Nomad SERVICE BULLETIN

EQUIPMENT AND FURNISHINGS — COCKPIT SUNVISORS NON-MAGNETIC ARM (MOD N720)

Figure 1 Placard Mounting Plate Pattern

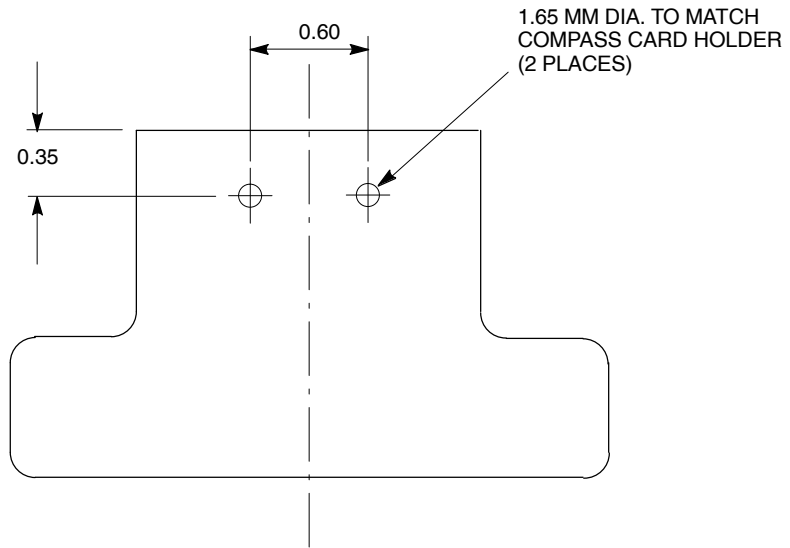
- (3) Install Warning Placard PN 1/N–00–337 on standby compass placard mounting plate.
- (4) If a placard mounting plate is not existing, remove the compass correction card and card holder from the mounting bracket and manufacture a placard mounting plate as shown in Figure 1. Position the placard mounting plate between the compass card holder and the mounting bracket and rivet in position using two MS20426AD2–4 rivets (Ref Figure 2). Apply the placard to the placard mounting plate and refit the compass card.

MATERIAL: 0.020 IN THICK AL ALLOY
2024-T4-3 ALCLAD
QQ-A-250/5
FINISH: PRIME AND PAINT MATT
BLACK.
